FOUNDATION INVESTIGATION AND DESIGN REPORT

PROPOSED SANITARY TRUNK SEWER AND WATERMAIN CROSSING OF HIGHWAY 401, COURTICE, ONTARIO

Regional Municipality of Durham

**Subject: Peer Review of Foundation Investigation and Design Report for Tunnelling
Sanitary Trunk Sewer and Watermain Crossing of Highway 401, Courtice
Region of Durham
HMM Project: 358397
WSP Project: 131-12884-00**

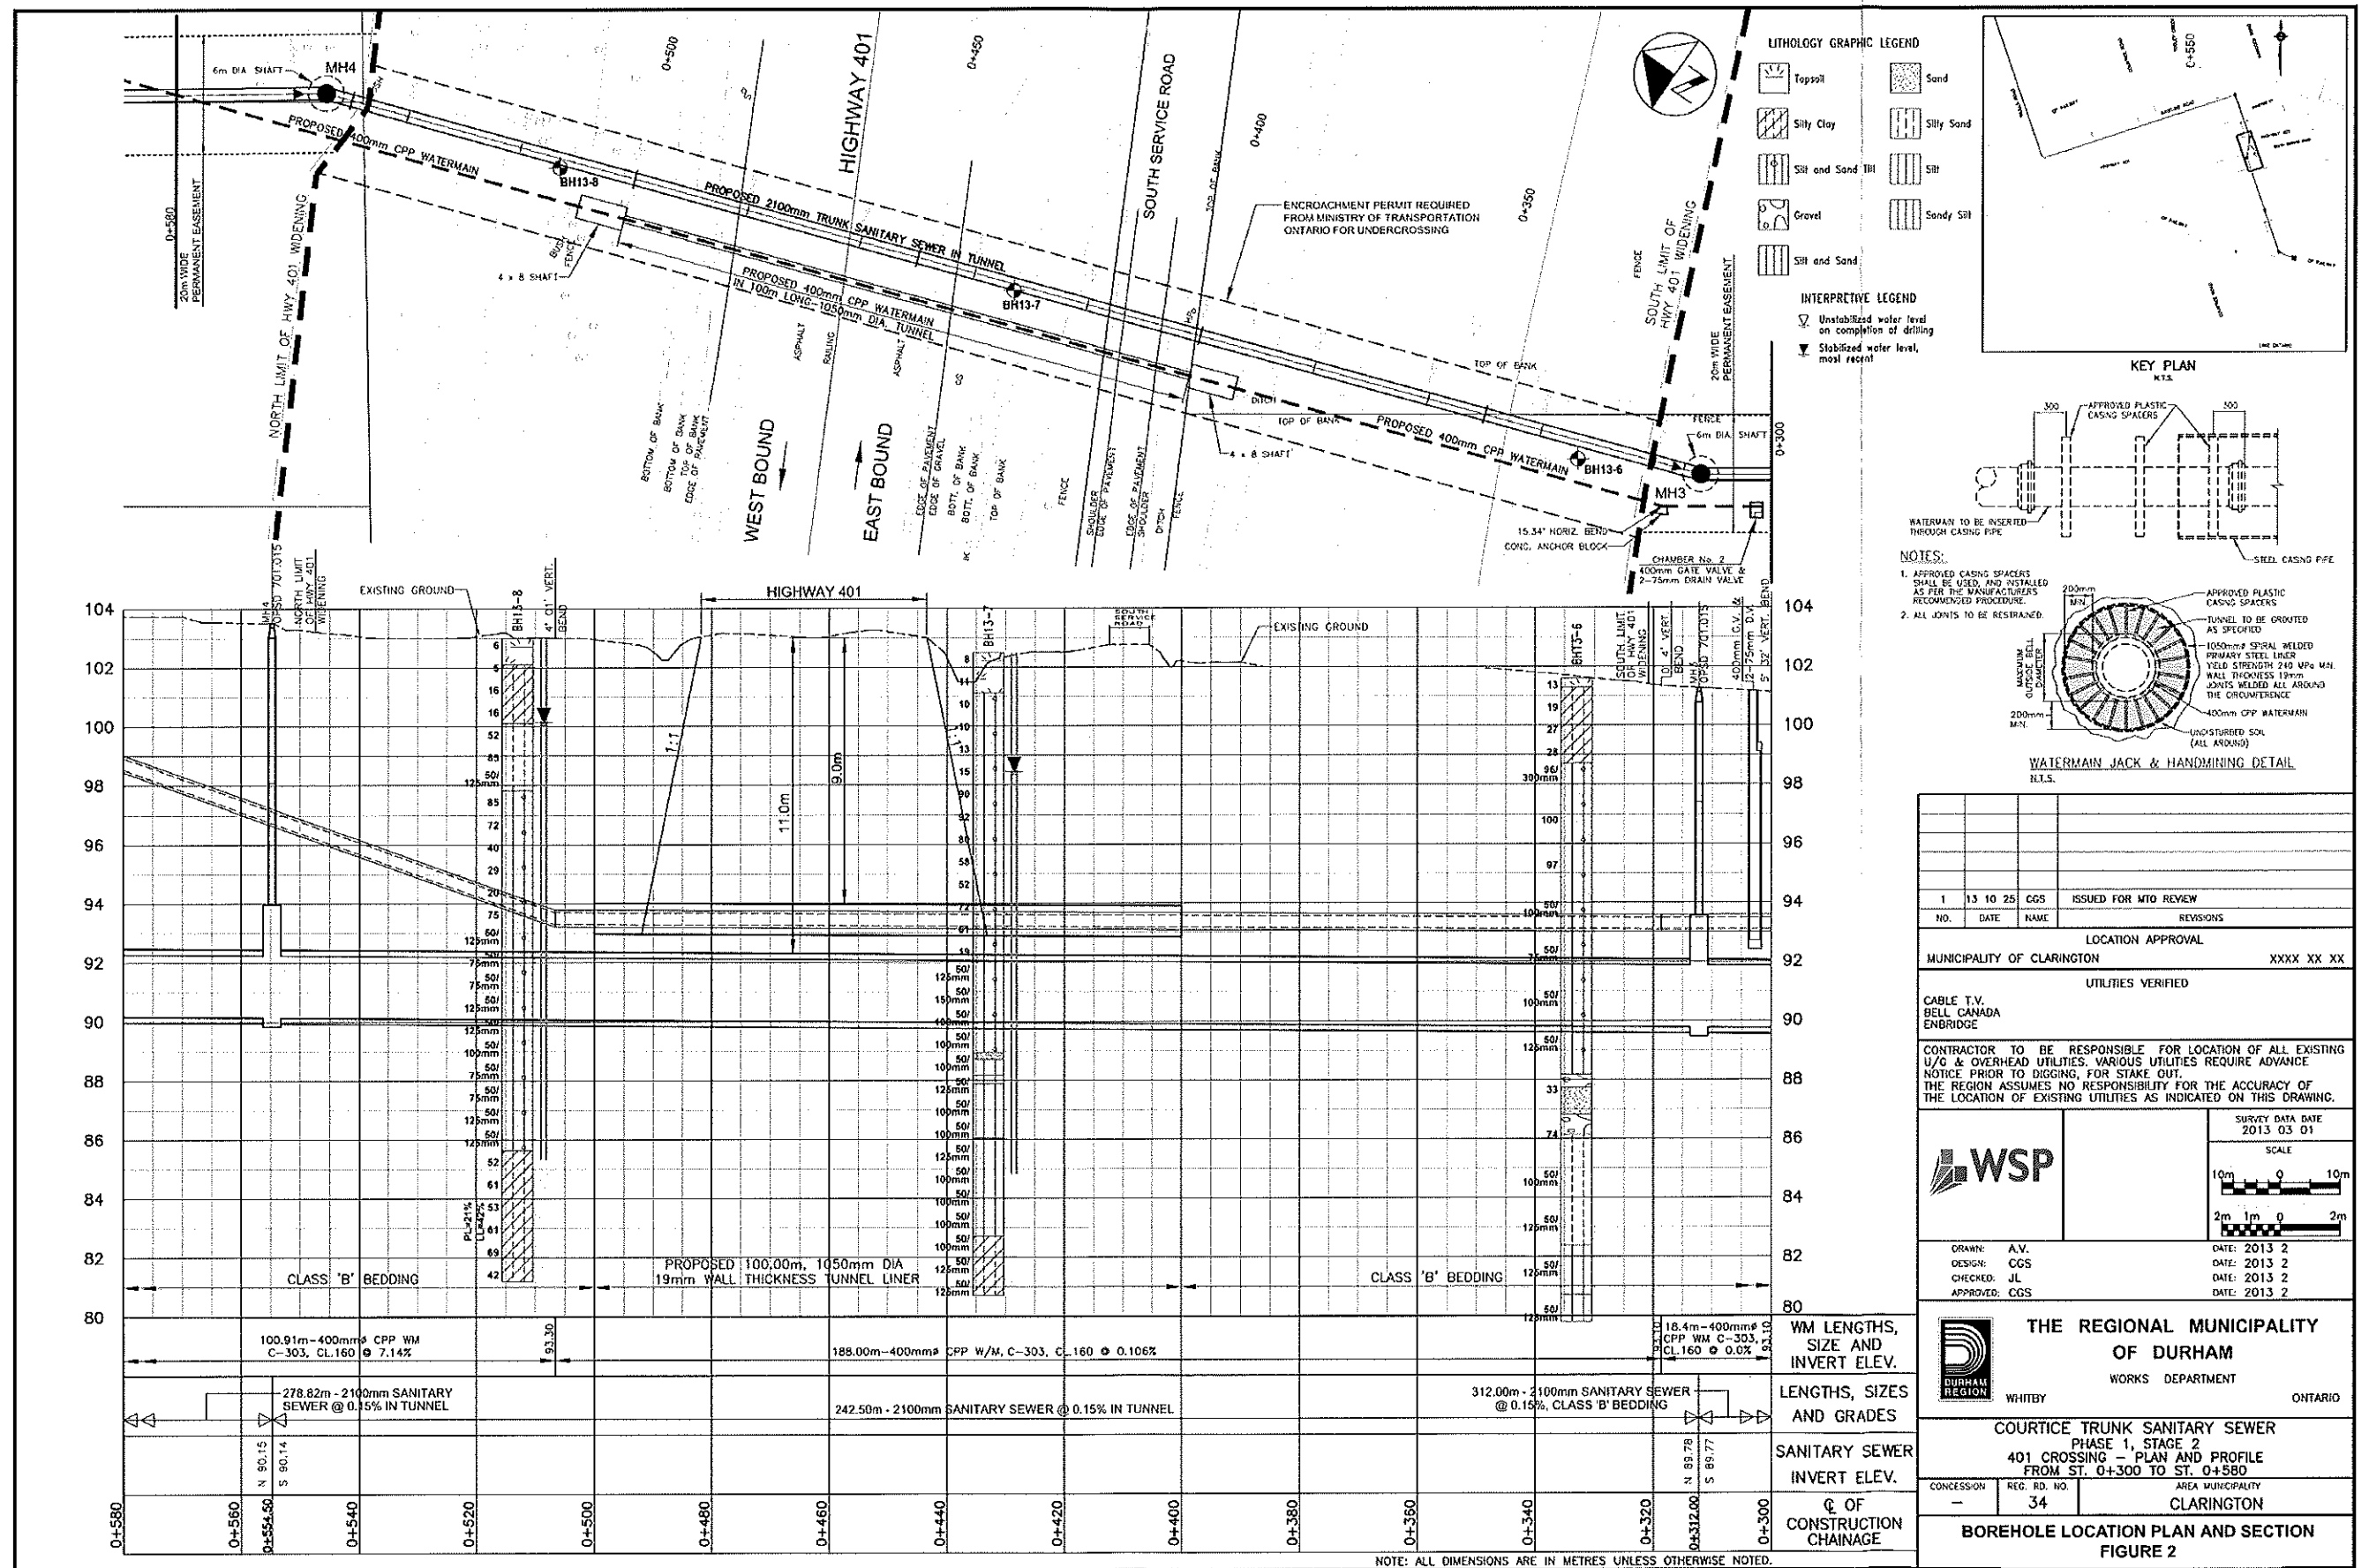
HMM reviewed Foundation Investigation and Design Report (WSP, 2014) and proposes the following modifications to the report or specifications:

3. Use of precast concrete segmental lining as the support for the 2100 mm sewer crossing is recommended. It should be clarified in the report that design of segmental lining will be the responsibility of the contractor and the design shall be performed for anticipated range ground in-situ horizontal and vertical stresses. WSP should provide vertical and horizontal ground stresses for the design of segmental lining.

4. With current location of shaft 401-S, South Service Road is expected to experience a settlement between 4 mm and 9 mm of vertical displacement due to excavation of Watermain Launch Shaft which is at a distance of 6 meters from the edge of excavation. Such settlement is anticipated to be in addition to any predicted settlement due to tunnelling. If the shaft 401-S can be relocated so it has a minimum 10.5 m setback from the edge of pavement, shaft excavation is not anticipated to impact the pavement.

5. The combined effects of both Watermain and Trunk Sanitary Sewer Tunnel should be considered in the settlement impact assessment. Based on HMM's calculations under anticipated ground conditions and using good tunnel construction workmanship, a settlement impact of 1 mm is predicted for Watermain tunneling and a total settlement impact of 3 mm to 4 mm is predicted for combined effects of both the Watermain and trunk sanitary sewer tunnels. These settlements are measured above the Watermain, assuming closed-face tunnelling/microtunnelling.
